ATTACHMENT A
FRAPCON3.2 Input and Release Calculations
for the Duke MOX Lead Test Assemblies

Duke Power Inc. (Duke) has submitted a license request to the Nuclear Regulatory Commission (NRC) to operate 4 mixed oxide (MOX) lead test fuel assemblies (LTAs) in the Catawba PWR, in support of the joint U.S./Russia program for disposition of weapons-grade plutonium. The predicted at-shutdown bounding radioactive gas inventory in the fuel rods available for release in a spent fuel handling accident (often referred to as the “gap inventory” of radioactive isotopes) is one of the items involved in the review of this request.

Figure 1: MOX LTA Power histories derived from time and burnup while the other is derived from radial peaking factor and core average power all supplied by Duke

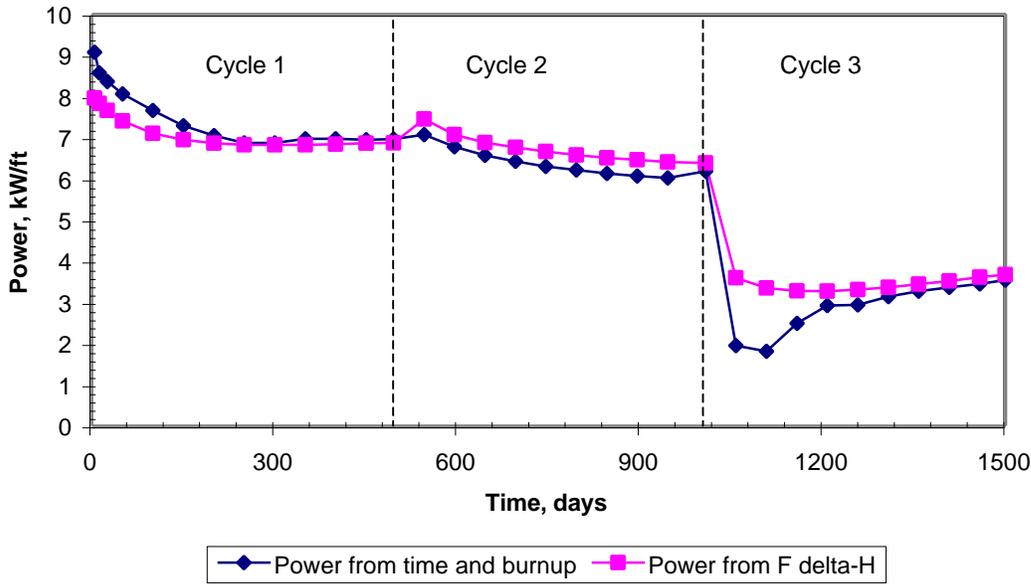
The power history used for this analysis was the one derived from burnup and time; however, some release results are given for the other power history to show that it provides slightly higher release values. The difference between these two power histories can be accommodated by the power uncertainties described later in this report. Time and burnup from Reference 2 provided a power history consisting of 45 pairs of time and power that were used as input for FRAPCON-3.2. The power histories provided in Reference 2 were characterized by Duke as being conservative and bounding for the expected power histories to which the MOX LTAs may be irradiated. Reference 2 also provided 18 axial power profiles and the times that each should be used during the irradiation life of the LTA's. These profiles were input directly into FRAPCON along with the time steps each should be used.

Figure 3: Nominal release results from ANS5.4 with the nominal power history modified to match Massih EOL FGR prediction

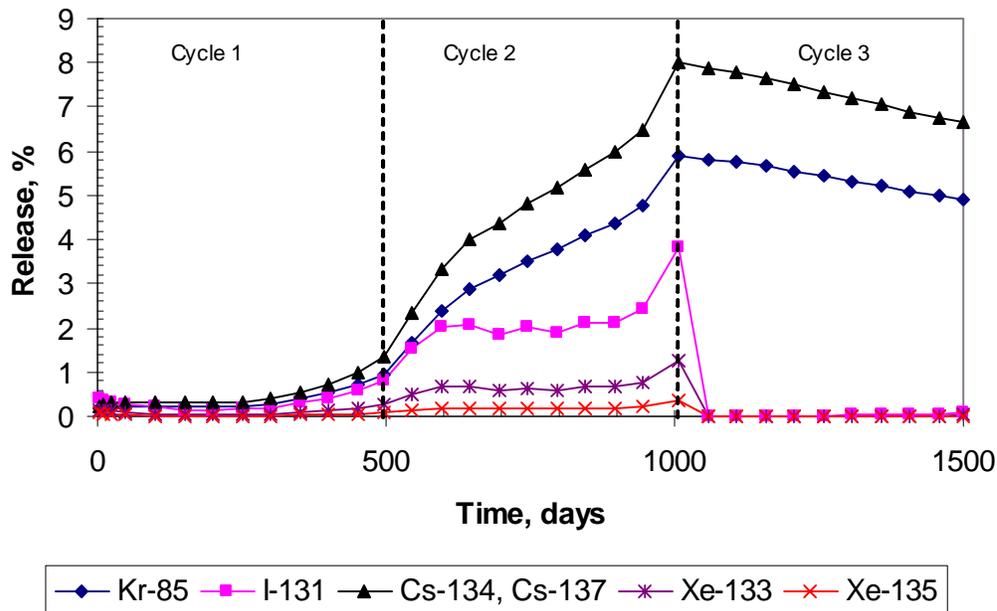
The NRC-NRR request was for releases at rod-average burnups of 25, 45, 50 and 62 GWD/MTM. However, examination of Tables 2 and 3 and also Figures 3 and 4 demonstrate that all the radioactive isotope peak release values occur at EOC2 (provided in Table 3 and Figure 4). These nominal peak release values calculated with the ANS5.4 model at EOC2 are bounded by the Regulatory Guide 1.183 recommended release values for these isotopes.
